**933**  
**INVITATION TO BIDS**

**South Park Manor Reclad**  
**Solicitation No. 5780**

ADDENDUM NO. 1  
Issue Date: August 10, 2023

This Addendum provides pre-bid meeting information (see Item 1 below), provide photos (see Item 2 below), extends due date (see Item 3 below), lists questions received and SHA's responses (see Item 4 below), and revised drawings provided (see Item 5 below).

A1.02

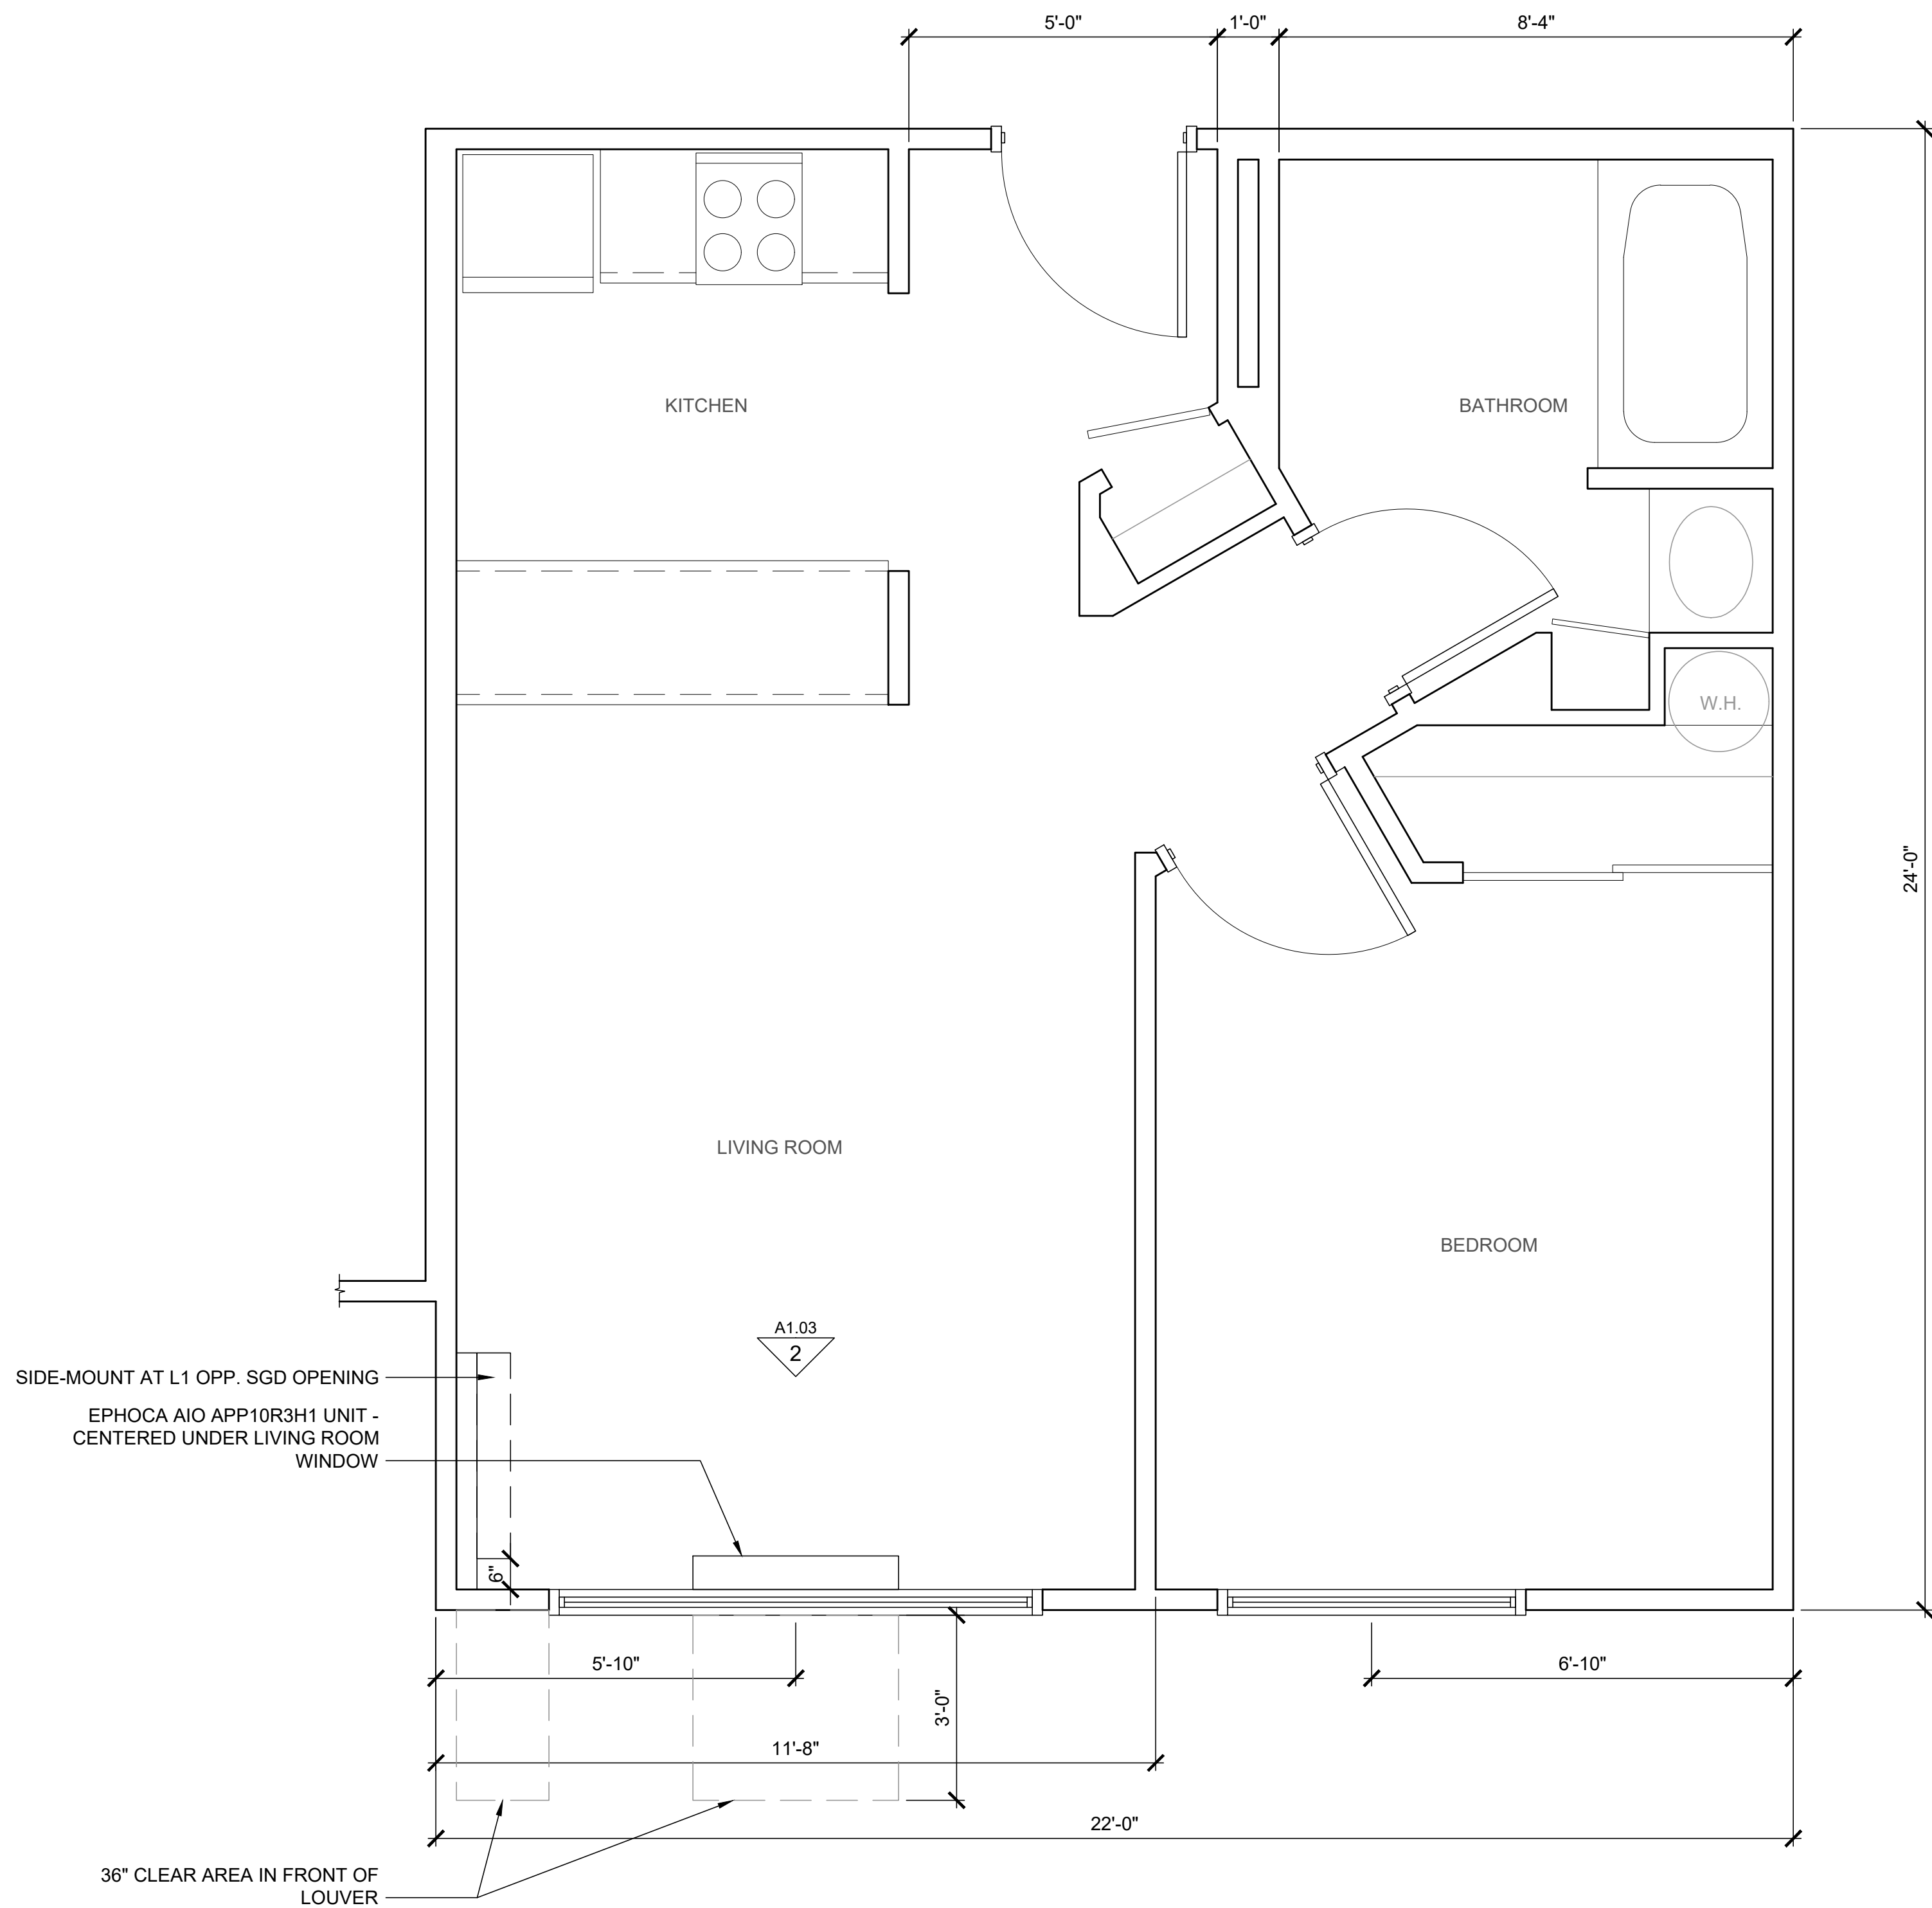
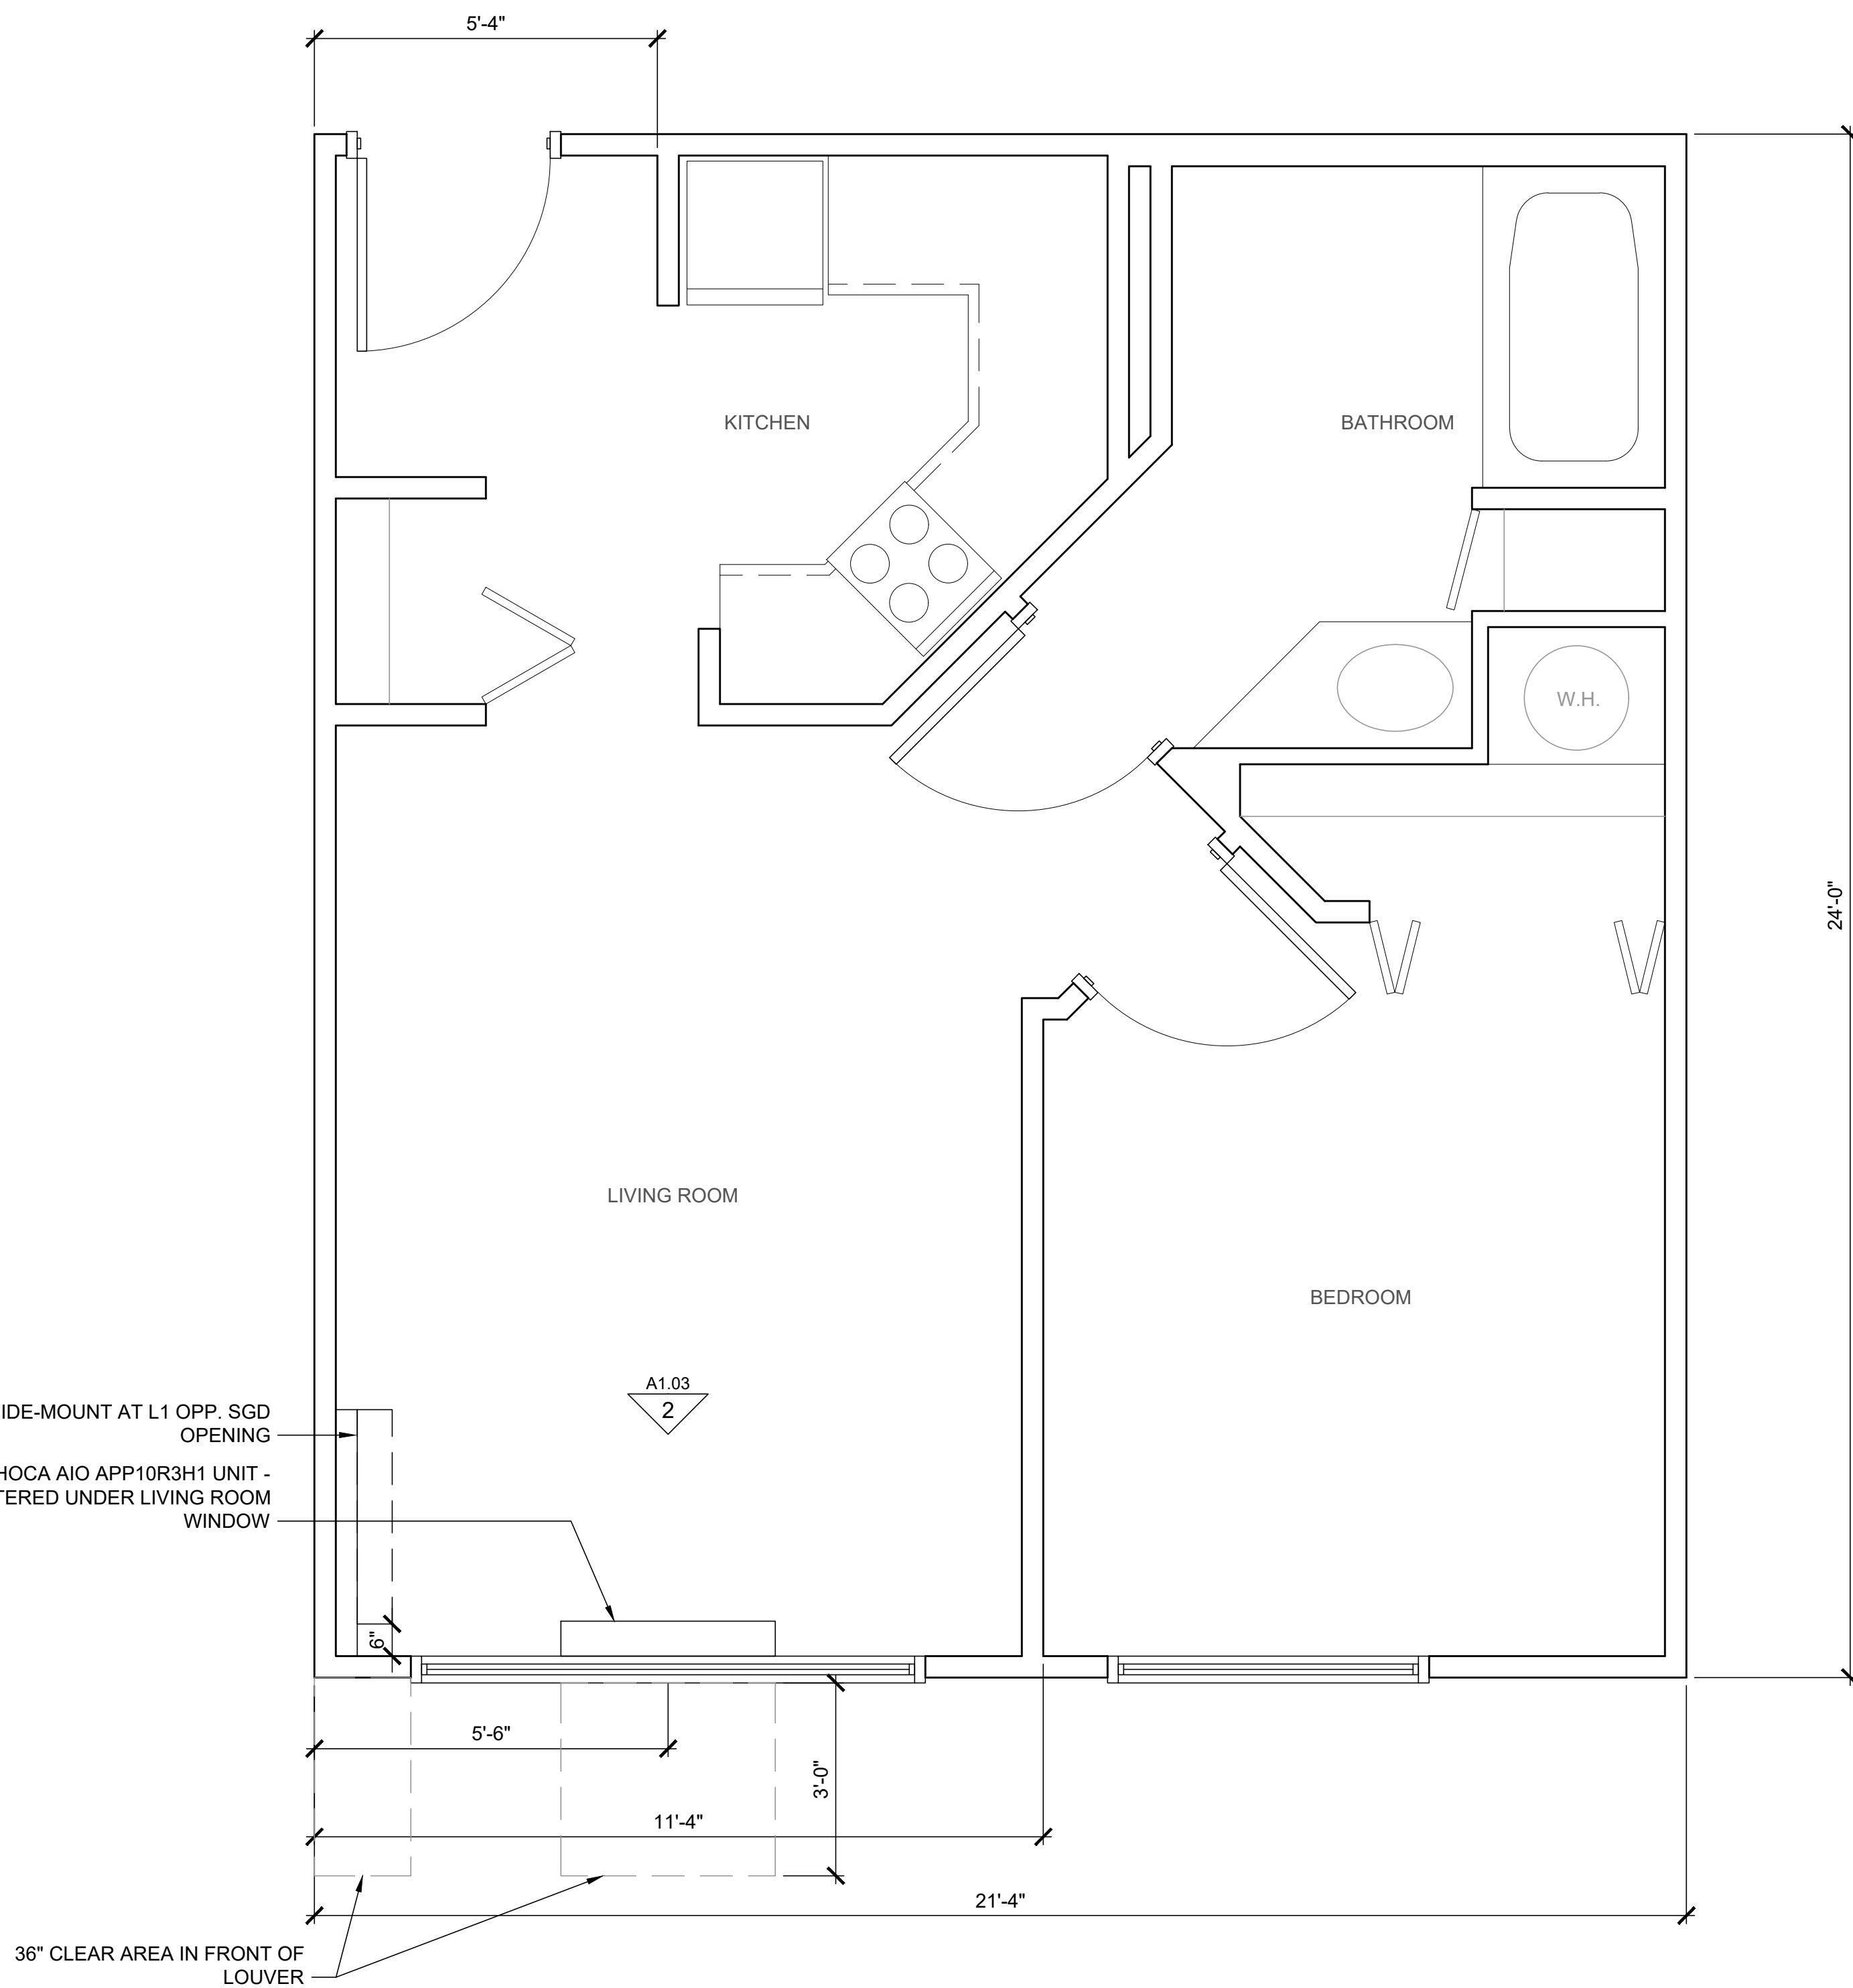
39	-DHP ERV – Please confirm if Wall Mounted Pro w/ERV APP10R3H1 (on spec Section 23 0000 Part 2 – Products 2.1 A.) or AWP10N4L1 (on drawings A1.02) models are to be used?	Correct ERV/DHP unit model: APP10R3H1
40	-DHP ERV – A1.04 contradicts A2.0 South elevation of building where intake and exhaust are located. Please confirm the installation of the DHP ERV at operable portion of slider vs on the inoperable side? Please confirm minimum clearance requirement for the DHP exhaust from an operable window or door.	DHP/ERV unit should be located on the fixed side of the sliding glass door where possible.
41	-Air Seal – Can you please confirm scope of work with air sealing interior switches and plugs? That is typically done during new construction, not renovation projects.	Confirmed - all interior outlets and switches should receive an air seal (in a practical manner) to meet OH standards.
